Annex I of TPB Paper No. 10176

Representation to the Draft Tung Chung Extension Area Outline Zoning Plan No. S/I-TCE/1 under Section 6(1) of the Town Planning Ordinance

**Representation to the Draft Tung Chung Extension Area Outline Zoning Plan
No. S/I-TCE/1**

Figure 2: Proposed OPTION 1

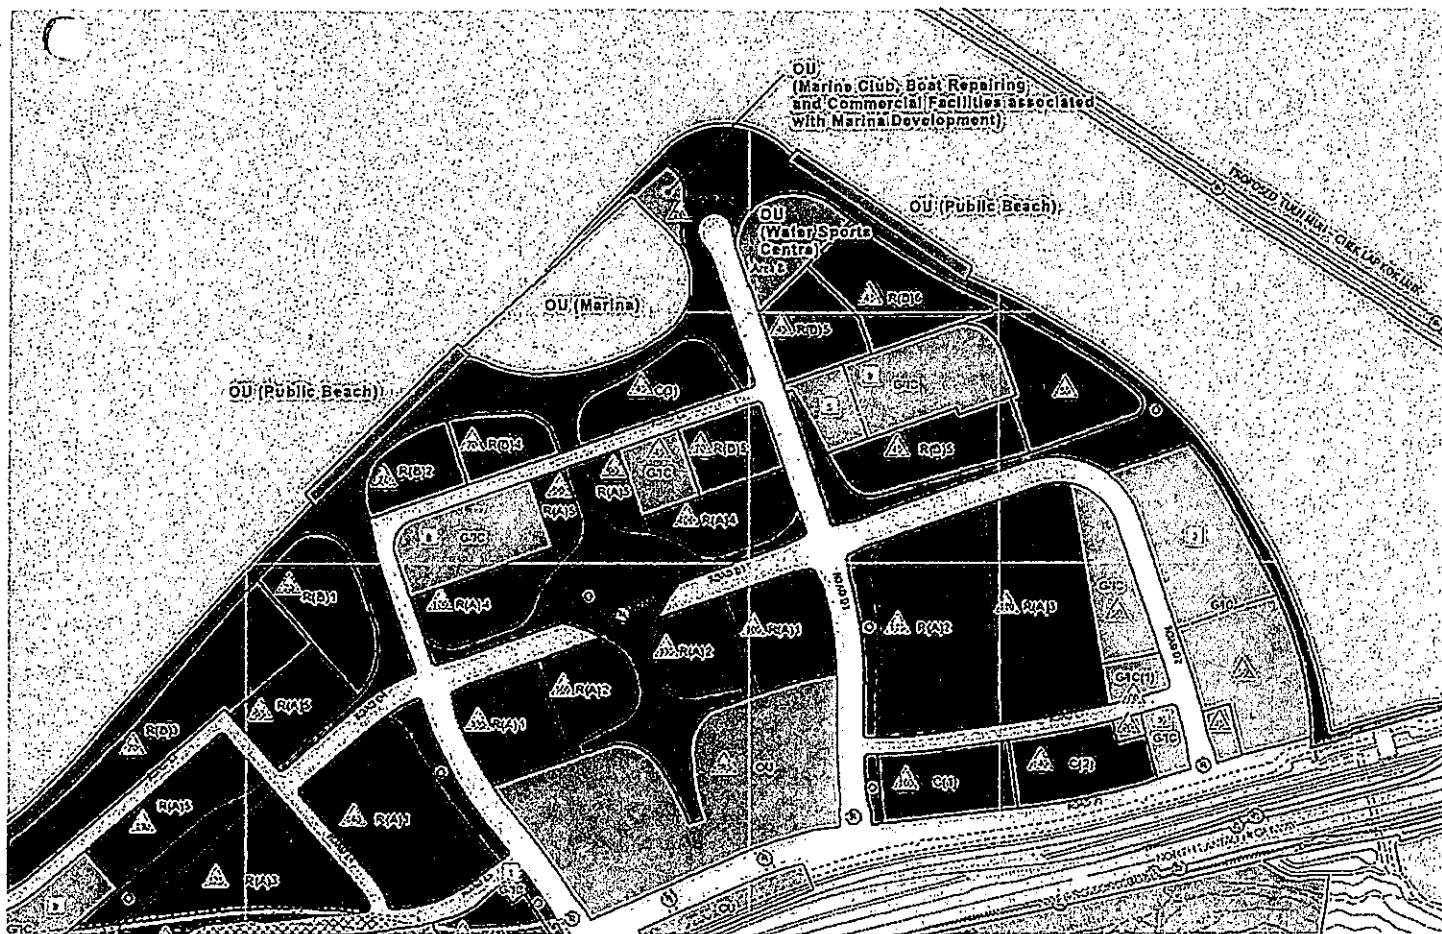
- 3.2 However, the design and layout of the marina has not taken account of practical features such as the need to keep good circulation of water through the marina to maintain good water quality. The proposed design also takes away potential land which could be used for a larger public park on the waterfront. An alternative layout is attached which will enable a marina to accommodate some 200 plus vessels, while providing a larger park and a marina support area (see Figure 2).

- 4.1.1 This option is fundamentally the same as that submitted with the Stage 3 Public Consultation and is illustrated in Figure 2. It involves the following:-

- (a) The expansion of the Planning Area boundary to include a portion of the sea to the north-west of the currently proposed marina. This new area would be shown as "OU(Marina)" and the proposed sea walls would be accessible to the public as part of the waterfront promenade;

- (b) The area previously indicated as the marina would be rezoned to "Open Space" and provides an enlarged waterfront park;
- (c) The zoning for Planning Area 144 be retained as "OU(Marina Club, Boat Repairing and Commercial Facilities Associated with Marina Development)", but enlarged and located adjacent to the re-aligned marina edge;

- (d) Area 143 be rezoned from "OU(Marina Club, Boat Repairing and Commercial Facilities Associated with Marina Development)" to "OU(Water Sports Centre)" with the Planning Intention of being "primarily to reserve land for water sports and recreation facilities";

Figure 1

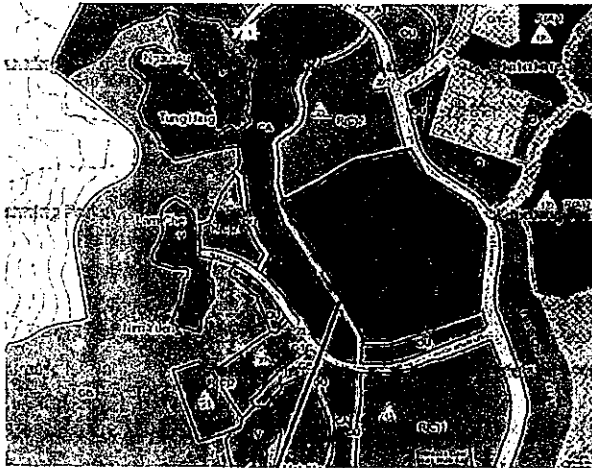
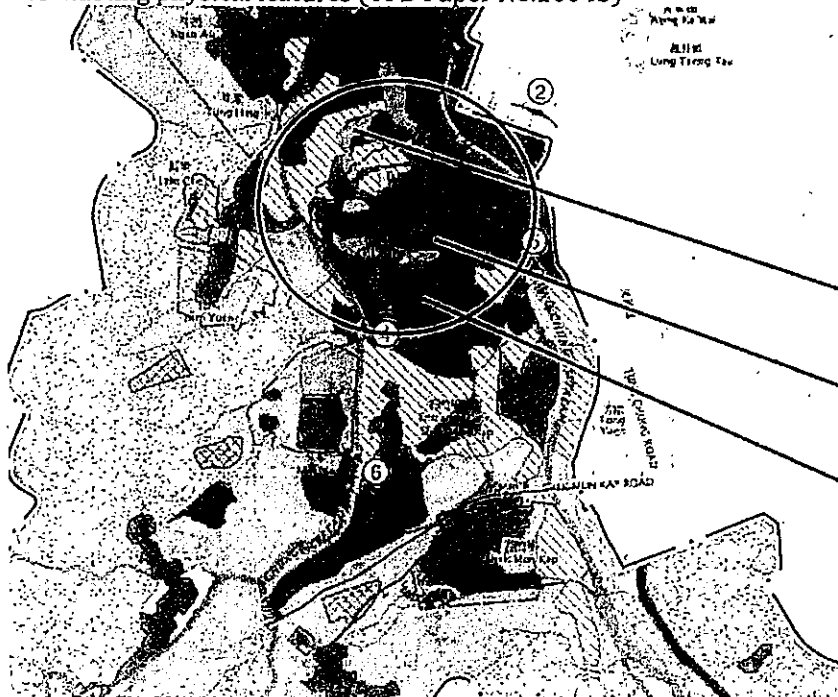
- The "V Zone" in Shek Lau Po has been extended and covered the surrounded "Agriculture" zones. This has not been justified in the EIA report. (Figure 1) According to the OZP paper No. 10045, there are active farmlands along Shek Lau Po and Shek Mun Kap. The "Agriculture" zones could serve as a buffer between the Tung Chung Valley and V zone to avoid pollutants from reaching the river and estuary and provide a better enhancement and management on flood control.

The "V zone" in Shek Lau Po has been extended and covered the surrounded "Agriculture" zones in OZP. This has not been justified in the EIA report.

Figure 2:

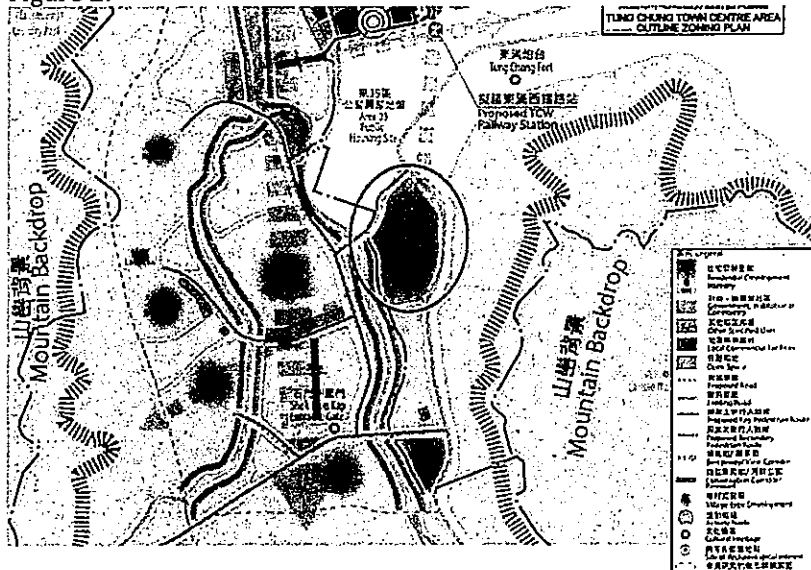
- The human disturbance and development threat brought from the "Residential" zonings will impact the natural and rural landscape, hydrology and ecology of Tung Chung Valley. In addition, the Area 42 and 46 zoned as "Residential (Group A)" ("R (A)") in Tung Chung Town Centre Area Outline Zoning Plan No. S/I-TCTC/21 will block the breezeway and view corridor at North-eastern part of Tung Chung Valley. (Figure 2)

The Area 42 and 46 zoned as "Residential (Group A)" ("R (A)") in Tung Chung Town Centre Area Outline Zoning Plan No. S/I-TCTC/21 will block the breezeway and view corridor at Northeastern part of Tung Chung Valley.

Figure 1. The proposed zonings around Ngau Au Village in the Digest and the indicated zonings in the EIA (the area of concern is indicated by the red circle).

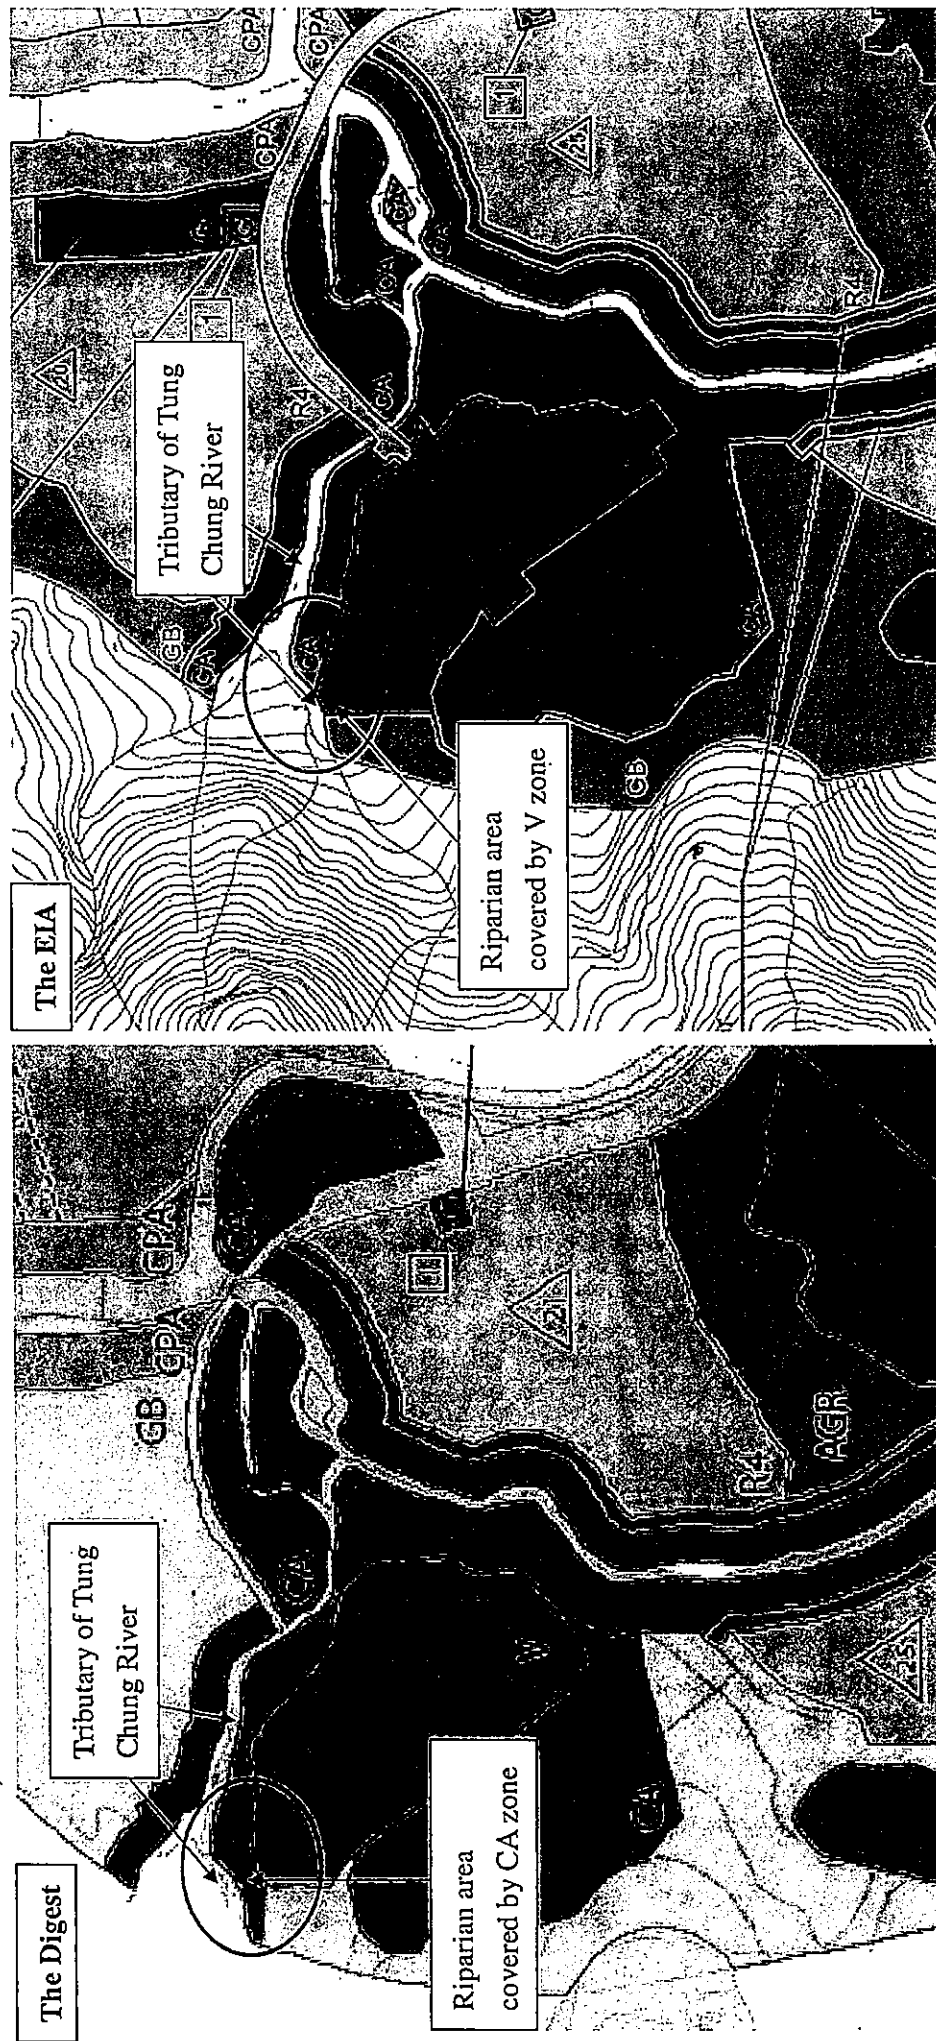
3.1 Figure 2.3 of the EIA (the Revised Recommended Outline Development Plan – TCW; RODP – TCW) shows that part of the riparian zone in an area to the northwest of the existing Ngau Au Village is recommended to be covered with a Village Development Area (V) zone. This is different to what is shown in the Stage 3 Public Engagement Digest (the Digest) for the same project¹. The area of concern is shown in Figure 1 of this letter. As indicated in the

Figure 5. Various figures showing the mature woodland area to the northwest of Ngau Au Village that is now indicated as a V zone under the EIA's proposal (approximately marked by the arrows).

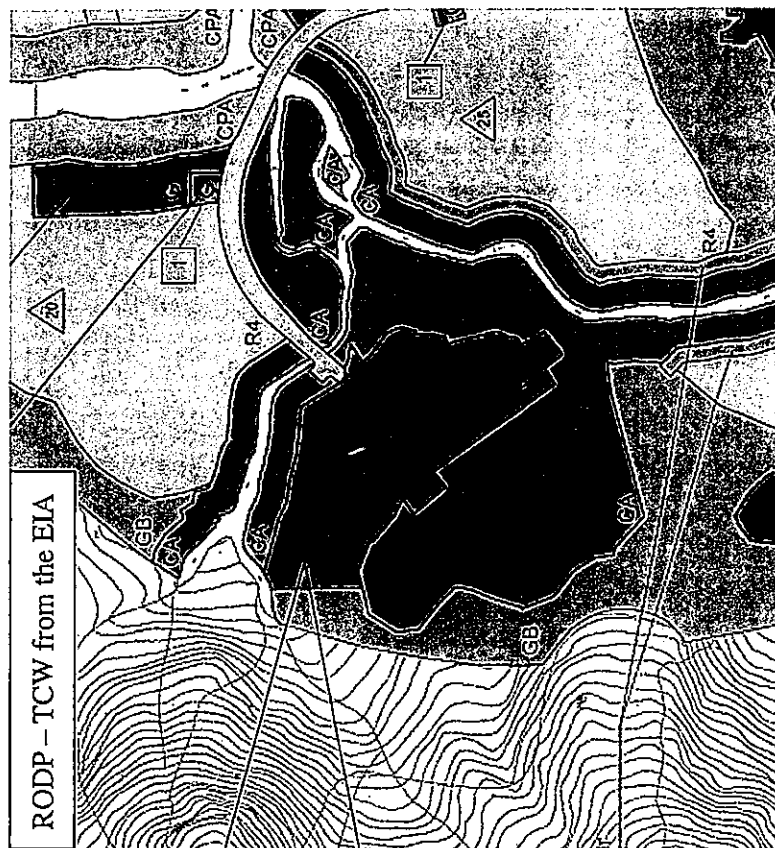
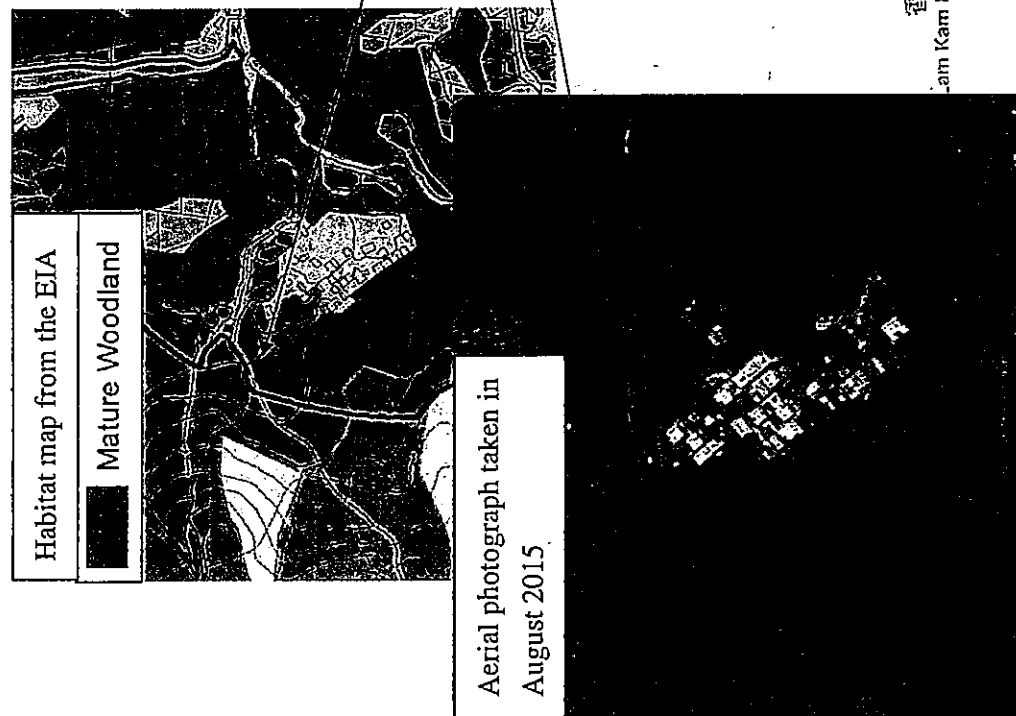
3.2 We do not understand how such an area (i.e., mature woodland and riparian zone of an important stream) could become zoned for village development (see Figure 5) – the potential impacts that would appear include the following: extensive tree felling, vegetation clearance, exposure of bare ground during site formation and, thus, potentially producing muddy surface runoff and sedimentation that would affect the nearby stream. All of these environmental impacts should be avoided in sensitive habitats, and the avoidance of such impacts can be facilitated, quite simply, by appropriate land use zonings (i.e., changing from a zone for development to conservation zonings such as CA). We are highly concerned that the potential and future construction of additional village houses within the proposed V zone will greatly affect (during both operation and construction) the mature woodland, the riparian zone and, also, the tributary which drains into the Tung Chung Stream which is considered to be the key ecological element and conservation focus of the Tung Chung Valley.

Figure 9. The potential movement corridor shown in the EIA actually passes through the proposed V zone near the existing Mok Ka Village.

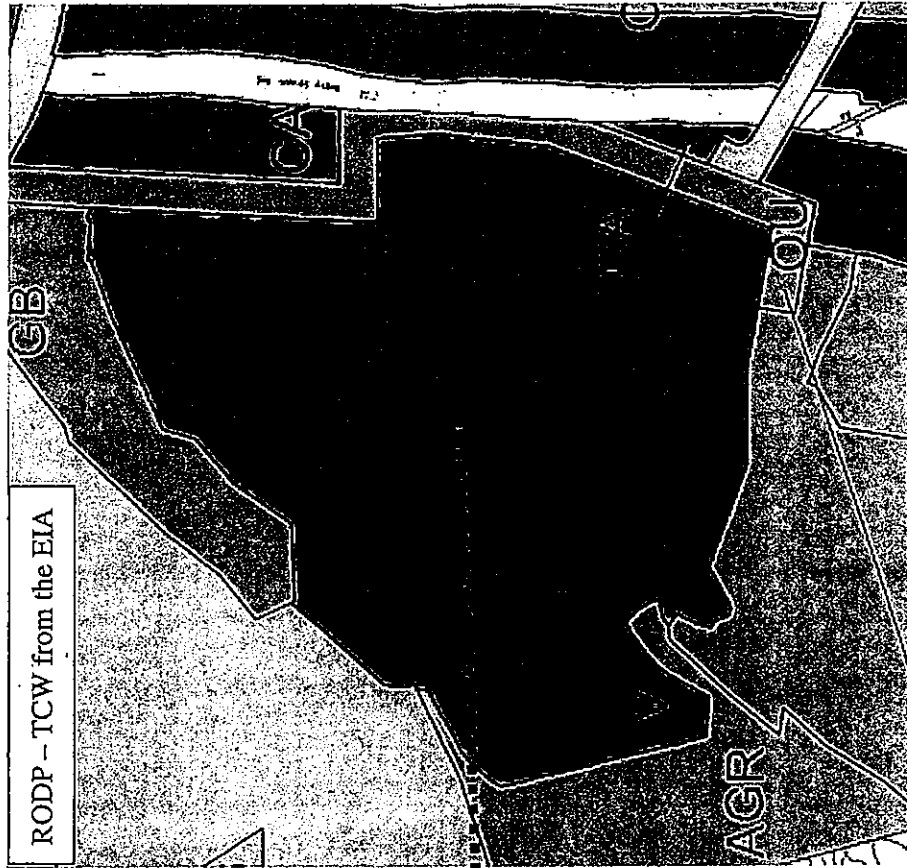
4.1 Figures 9.9b and c of the EIA show the ‘potential’ movement corridors of wildlife (including non-flying animals) during the operation phase. We consider that the efficacy of at least one of these so-called ‘potential’ corridors is misleading. The potential corridor to the north of the development area TCV-5a would indeed pass through a proposed V zone at the western end (Figure 9). The proposed V zones, as mentioned above, are of course intended for village development and it is common sense to expect that the man-made destruction effects within these zones would be intense. Under such dire circumstances, how can the so-called corridor passing through this area still be considered to be a potential functional area in the EIA? This is absolutely misleading.

Figure 10. Valid movement corridor (solid arrow) with conservation zonings recommended by KFBG (approximately indicated by the green rectangle with dotted boundary) adjacent to Mok Ka Village.

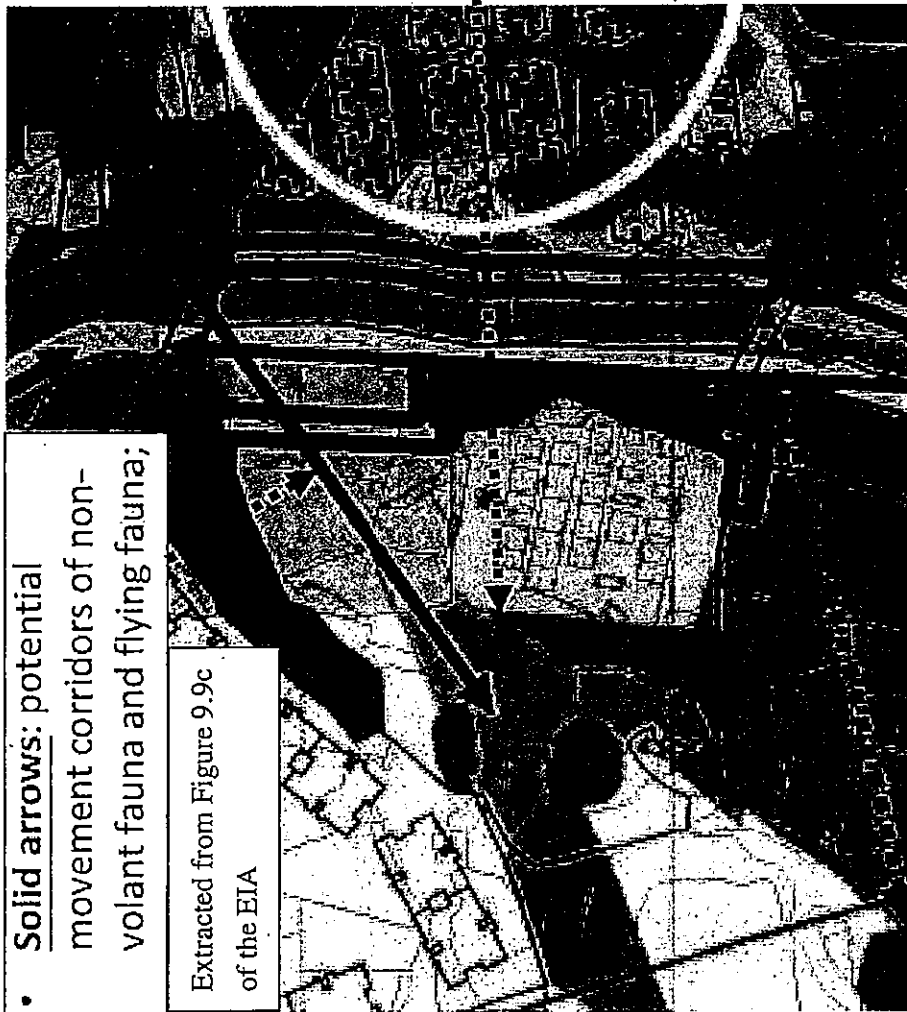
4.2 We urge that, in order to create viable movement corridors, these areas should not pass through or be encompassed by any zones intended for development (e.g., the V zone). We strongly urge for conservation zonings (e.g., GB, CA) to facilitate viable movement corridors and our recommendations are shown in Figure 10. In addition, we request that the GB and CA zones to the south of areas TCV-5a and 5b should be increased in size in order to widen the potential movement corridor for wildlife (also shown in Figure 11).

Figure 13. A large piece of proposed GB zone to the north-east of Ngau Au Village shown in the Digest, which is currently well vegetated, that is now zoned as R4 in the EIA.

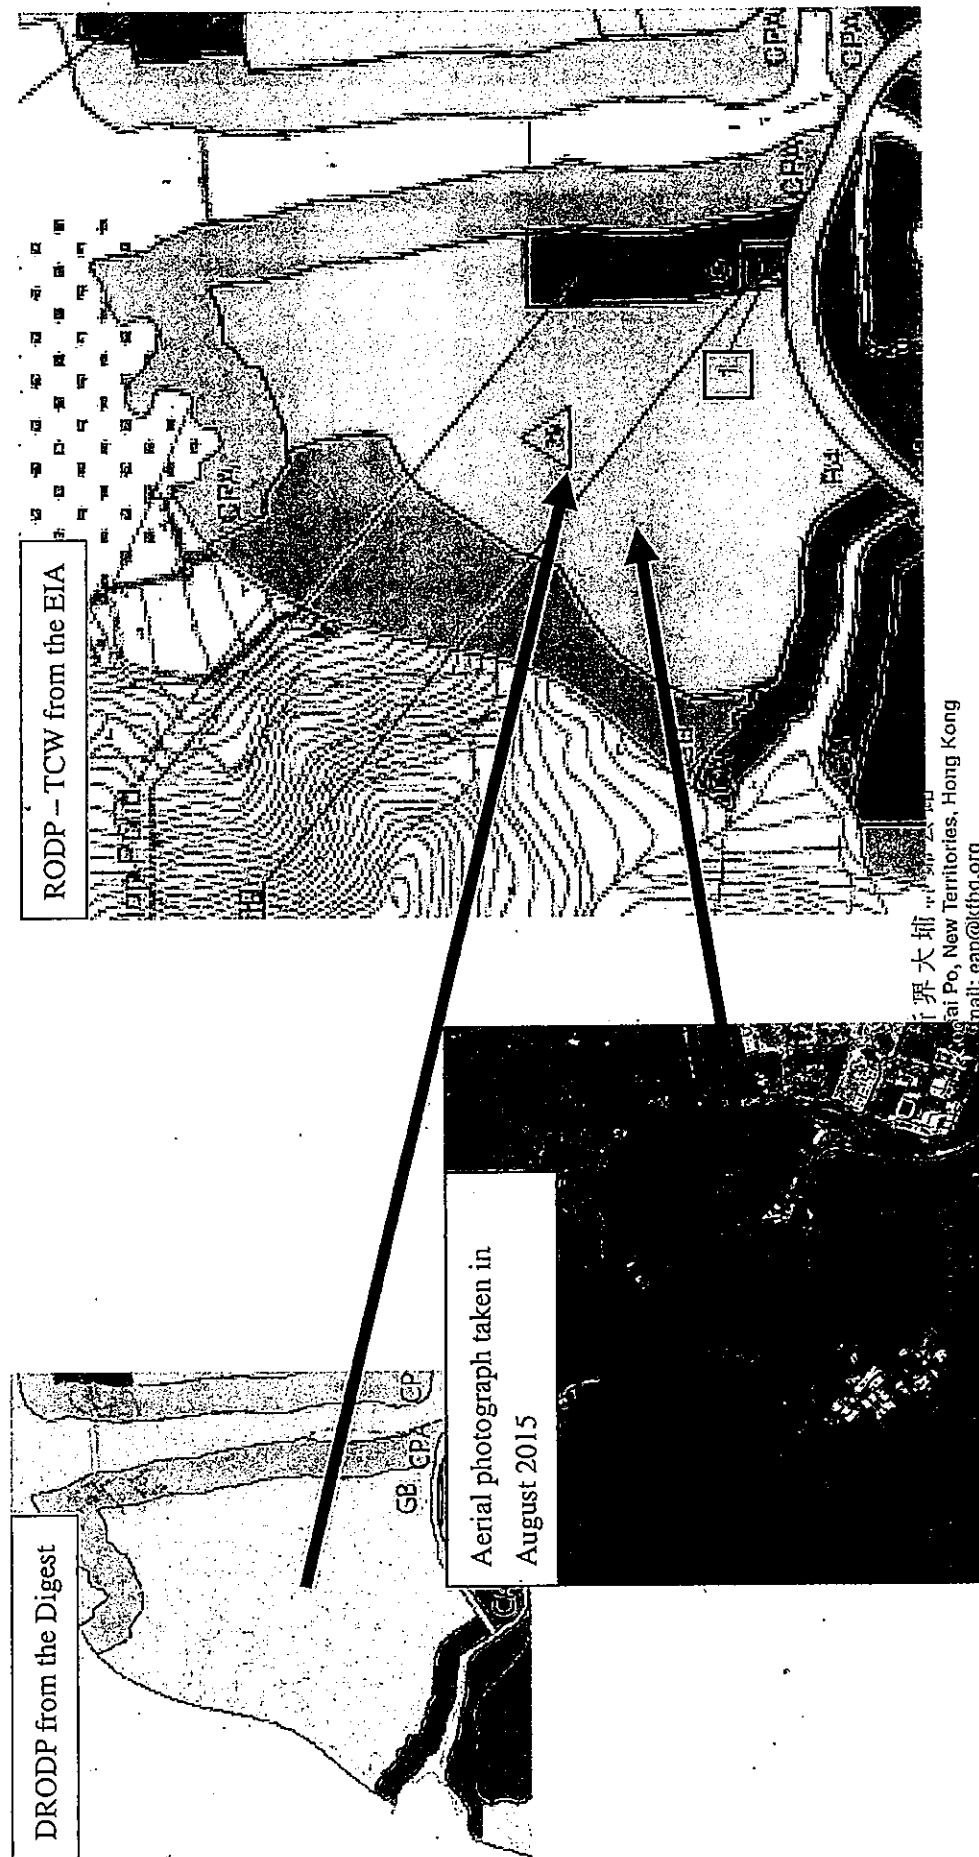
5.1 The area TCV-8 is now covered with a residential zone according to the EIA. However, as shown in the Digest, this area was previously proposed to be a GB zone under the DRODP (see **Figure 13**). We consider this is to be significant change (the area is about 4 ha) and we hope the ACE would request for elaborations from the authorities as to why there is such a major change. According to Figure 9.6a of the EIA, this area is largely an orchard and Romer's Tree Frog was recorded in the vicinity. As shown in an aerial photograph taken in August 2015, the area (TCV-8) is currently largely vegetated (**Figure 13**). We consider that it is still ecologically linked with the Tung Chung Stream, the coastal habitats, and the hillside woodlands. As mentioned in our Technical Report for the Tung Chung Valley area, Romer's Tree Frog has been recorded in the orchard habitat in the valley⁴ and is definitely able to utilise the orchard within the TCV-8 area. Following the RODP – TCW in the EIA, the orchard habitat in this area will be permanently lost. We strongly oppose the latest zoning proposal for this area as recommended in the EIA. We urge the authorities to re-zone the area back to GB as previously indicated in the Digest.
